## Staff Report

To: Planning & Zoning Commission  
From: Amy Tweeten, AICP, City Planner  
Report: June 7, 2022  
Meeting: June 21, 2022  
Item: PPUD21-0002 : PUD Final Development Plan (FDP) and Preliminary Plat request for Culver's Crossing (Parcels # RPS0082001004AA, RPS0082002001AA, RPS0082002010BA and RPS0082002009BA)

**Figure 3: Culver's Crossing Site Plan**

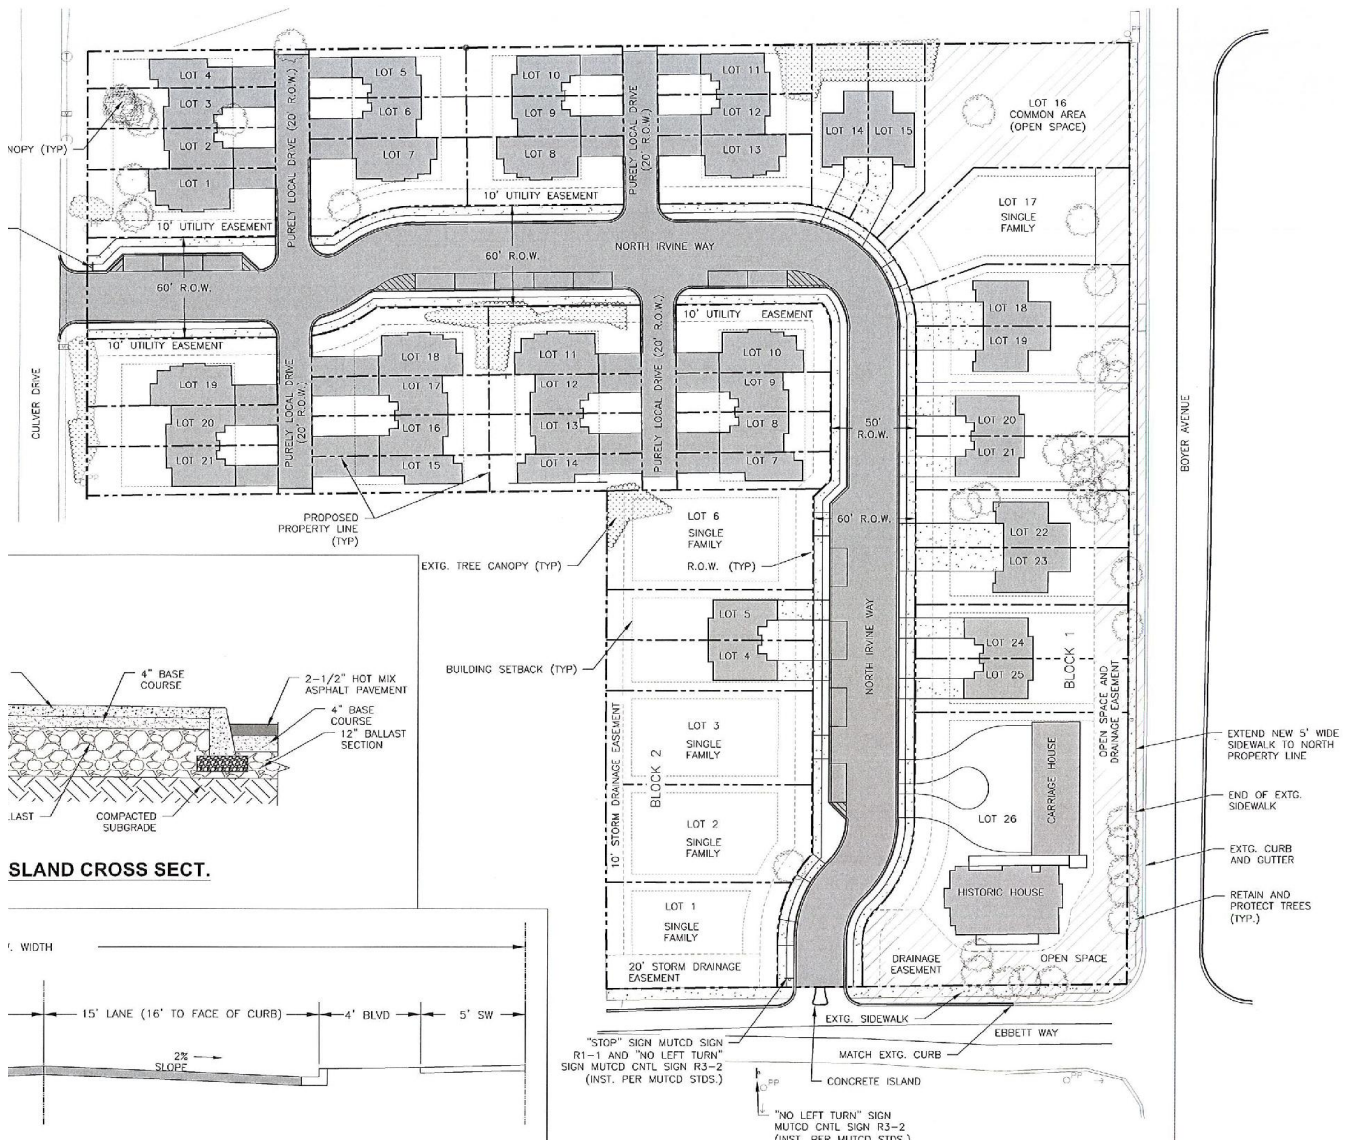
The distance between Irvine Way and N. Boyer Ave is less than the recommended 250 feet intersection spacing for a local residential street at 160 feet. The TIA did not identify this as an issue, due to the proposed right-in/right-out median approach shown to prevent left-turn conflicts. However, this type of median makes winter maintenance difficult along both Ebbett Way and Irvine Way. See condition of approval to omit median and provide "No Left Turn" sign.

"Irvine Way" is shown as a majority 60-foot right-of-way. The bend and the south end intersection at Ebbett Way are shown as a 50-foot right-of-way, a requested deviation from the required 60' for a local street allowed through the PUD process. Winter maintenance is a challenge with the proposed street cross-section combined with the narrow townhouse lots and subsequent closely spaced driveways (see **Figure 6**). The development also includes purely local drives (20 feet in width; public rights-of-way) to the Big House units, as allowed by §10-1-6-A-1. Winter maintenance for the purely local drives is also a challenge for City equipment. Due to the request for deviations and associated maintenance challenges associated with an approval, a condition has been provided to require public rights-of-ways be privately maintained. Public right-of-way dedication is necessary (in lieu of a private street) to enable enforcement of the law.

8. Provide "No Left Turn" signs at the intersection of Irvine Way and Ebbett Way.
9. All existing drive approaches to N. Boyer Avenue shall be removed and curb installed. The plat shall provide a note prohibiting any access off N. Boyer Avenue applicable to lots 16-26.

**Figure 7A Existing Water and Sanitary Sewer**

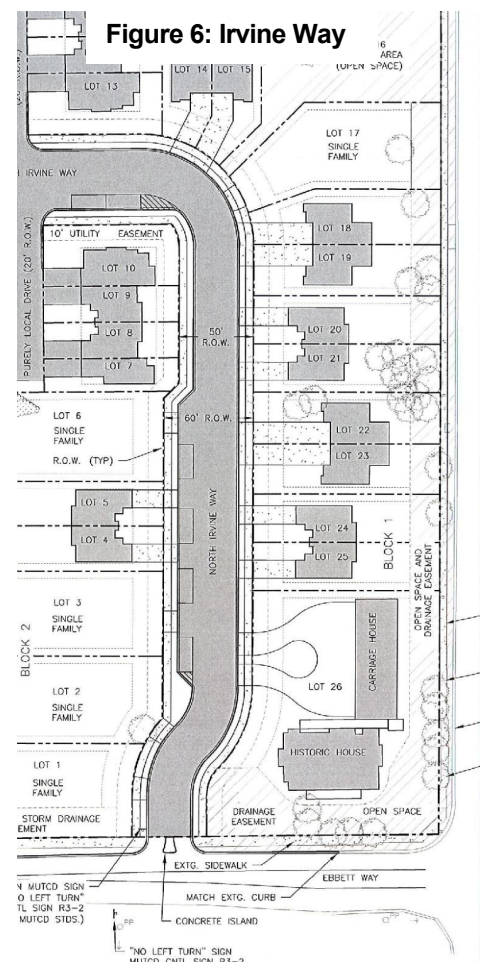
As shown in Figure 7A, an existing 8-inch sewer main located within Culver's Drive is available to serve the proposed development. The preliminary utility plans indicate a new combination pressure and gravity sewer main system is proposed, that will connect to the existing sewer system. Due to the inability to serve the site with just gravity flow, there are several lots with private grinder pumps that will pump to a public force main in Irvine Way and ultimately connect to existing gravity sanitary sewer through a new manhole in Culver's Drive.

The Water Rules, VIII.3 New User Facility Fee (NUFF) will be required for new connections. Individual service lines are required for all single-family homes and for each multifamily building. Proposed mains shall be looped in minimum grids of 1,320 feet by 660 feet or less in dimension. Existing 8-inch watermains on Ebbett Way and Culvers Drive are available to serve the proposed development, creating a looped system.

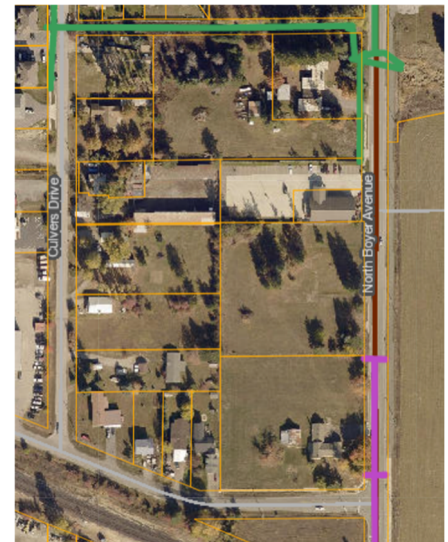
<b>Standard</b>	<b>Meets</b>	<b>Comment</b>
60' Minimum Right of Way for Local Street (50' allowed for a PUD per §10-1-6-A-1), except purely local drives	Yes	Irvine Way predominantly 60', with reduction to 50' at curve. The reduced right-of-way width, along with the narrow lots (close proximity of driveways) will make winter maintenance difficult. Purely local drives reduced to 20' width. See more detailed explanation above and associated conditions.
Transportation Plan Conformance	Partial	Irvine Way is less than 250 Feet from N. Boyer Ave. The applicant's proposed solution is to install an island that would prohibit left turns, however, due to operational concerns, the island should be removed and a "No Left Turn" sign installed in its place.
Right of Way Adjoining Undeveloped property	Yes	Adjoining property is developed.
Block Length less than 600 Feet	Yes	The orientation of Irving Way meets the requirement from the bend to Culver's Drive and to Ebbett Way.

Street Arrangement	Yes	Irvine Way connects to Culver's Drive and Ebbett Way.
Double Fronted Lots Double frontage lots are those created by either public or private streets, but not by driveways or alleys. Double frontage lots shall be prohibited except where unusual topography, a more integrated street plan, or other conditions make it undesirable to meet this prohibition. Subdivisions providing a platted common space of twenty-five feet (25') or more between any street right of way and any single row of lots shall not be considered to have platted double frontage lots. Common space provided must be landscaped.	Yes	Lots 1-4 and 17-26, Block 1 and Lots 19-21 Block 2 technically qualify as double frontage lots. However, the development provides an integrated street network without creating new access points (streets or driveways) onto N. Boyer Avenue, which is prohibited by the Urban Area Transportation Plan Appendix G. City Code requires compliance with the transportation plan. In addition, the development does have a 20-foot common space buffer. A condition of approval in accordance with Appendix G is noted below.

Street Grade (5% Max)	N/A	Generally flat area.
Parks, playgrounds & schools considered	Yes	Common open space provided; ultimate design to be determined by HOA. Condition provided.
Traffic Analysis	Yes	TIS completed; no extraordinary fees.
Private Streets	N/A	All streets will be public with privately maintained. Condition provided.
Interconnection	Yes	Subdivision creates a connected street and sidewalk network.
Street Intersection	No	See Comment under TIA
Driveways	Partial	Block 2 Lot 18 appears to be less than 35 feet from the edge of Irvine Way pavement. Condition of approval added below.

17. The driveway edge for Block 2 Lot 18 shall be no less than 35 feet from the pavement edge of Irvine Way.
